# PERMIT

SEWAGE DISPOSAL SYSTEM

ADDRESS 10439 Frederick Road, Ellicott City, Md. 21043 PHONE 465-6646

ADDRESS 9808 Route 108

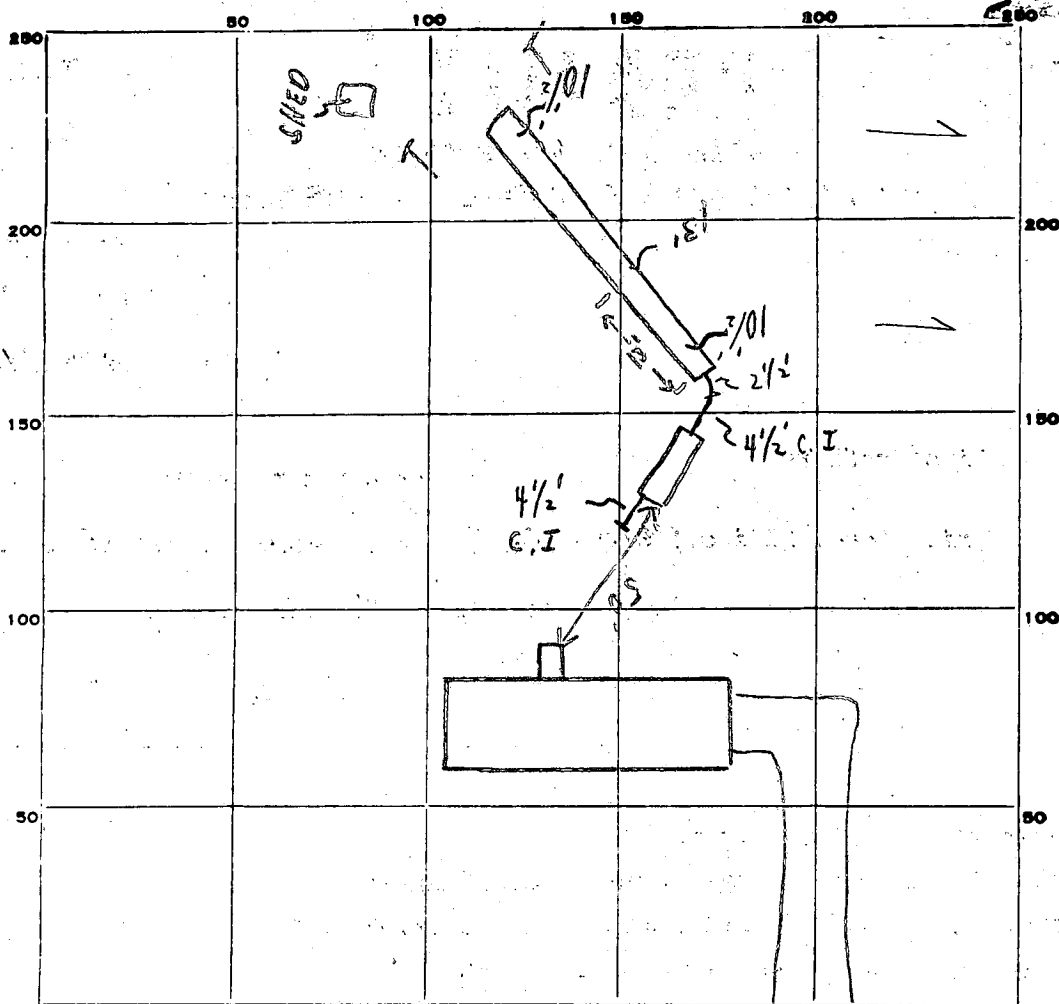
REPAIR. 2/19/81 Replace metal septic tank with new  
concrete type and run 50' of trench off of  
septic tank as indicated. 2' wide, 10'-10 1/2' deep  
6' of stone under pipe. C.B.

REMARKS 4/17/81 (1) OK FOR TRENCH 50' LONG; 10 1/2' DEEP; 2' WIDE;  
(2) OK TO PUT STONE IN TRENCH; OK TO COVER TO 3' OF  
TRENCH. (3) System complete.  
C.B.S. C.B.S.

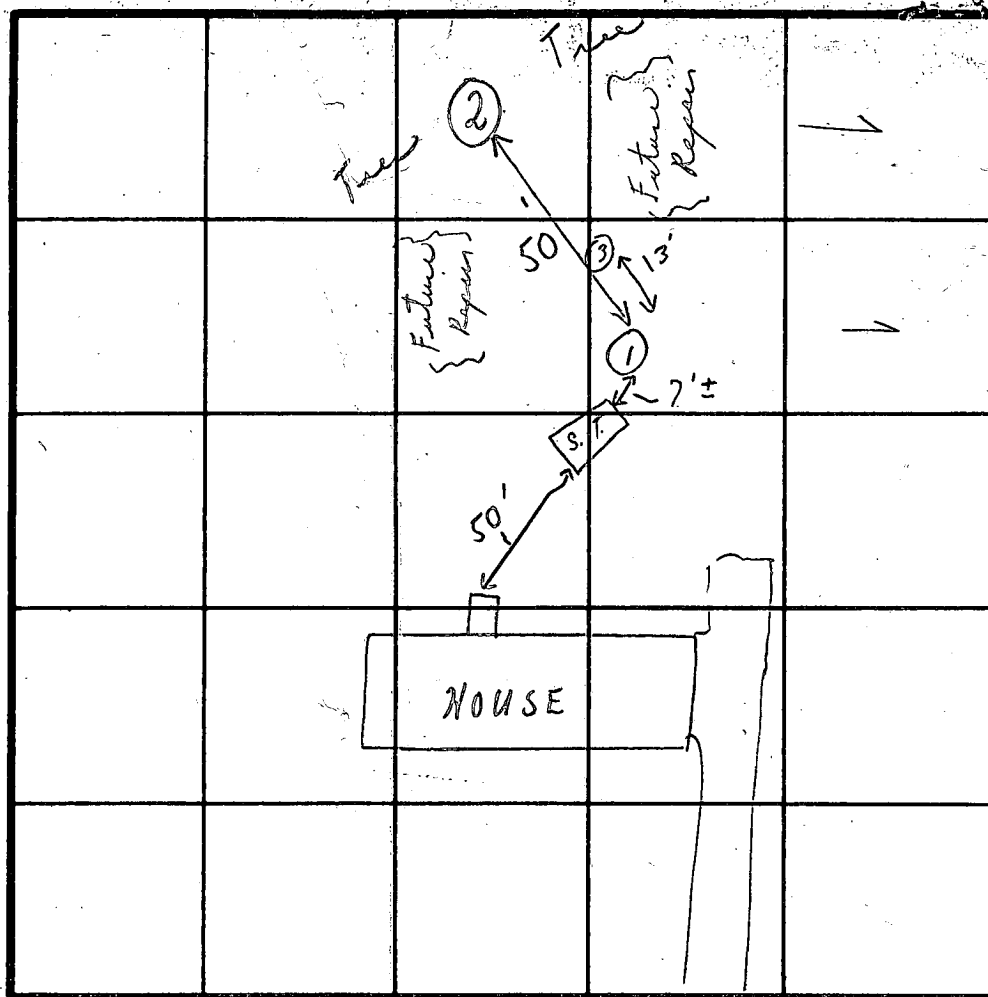
REASONS FOR REJECTION OR HOLDING 2/19/81 Existing house - 2 Bedrooms per Mr. Jenkins;

OK due to sandy loam soil for 50' trench  
2' wide, 10'-10 1/2' deep with 6' of stone under pipes.  
See attached permit C.B.O.
